Service Bulletin

NO. 1223

September 1, 1989

Subject: Models 33 thru 76 Variable Motor Housings.

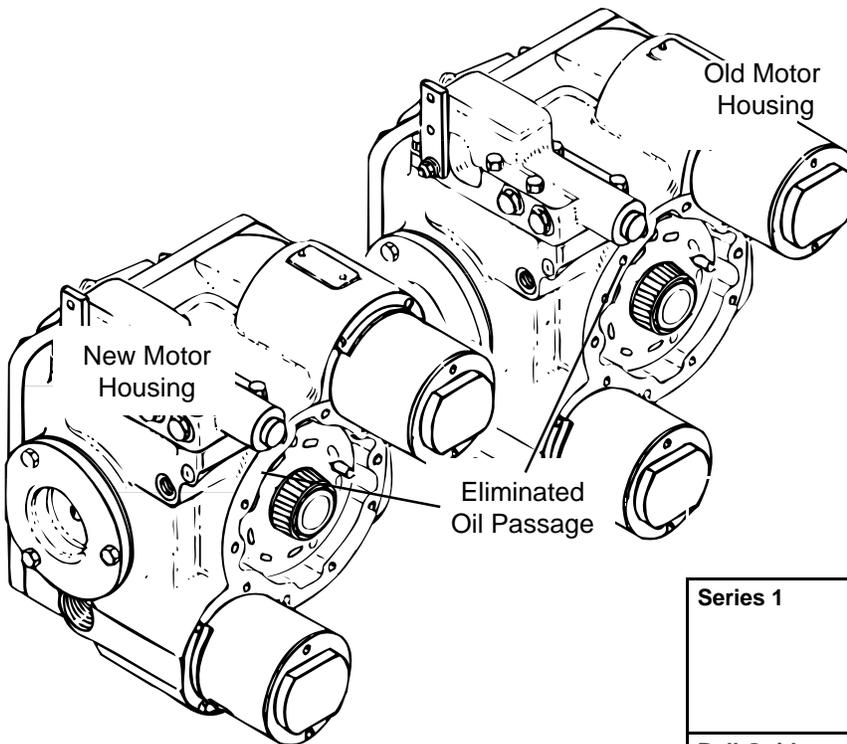
The housings used on all heavy duty variable motors have been changed. One of the internal oil passages has been eliminated. As a result the variable motor and pump housings are no longer interchangeable.

The drawing below shows the difference between the housings and the table summarizes their part numbers:

Use of the new motor housing begins with serial number 11 88 036200.
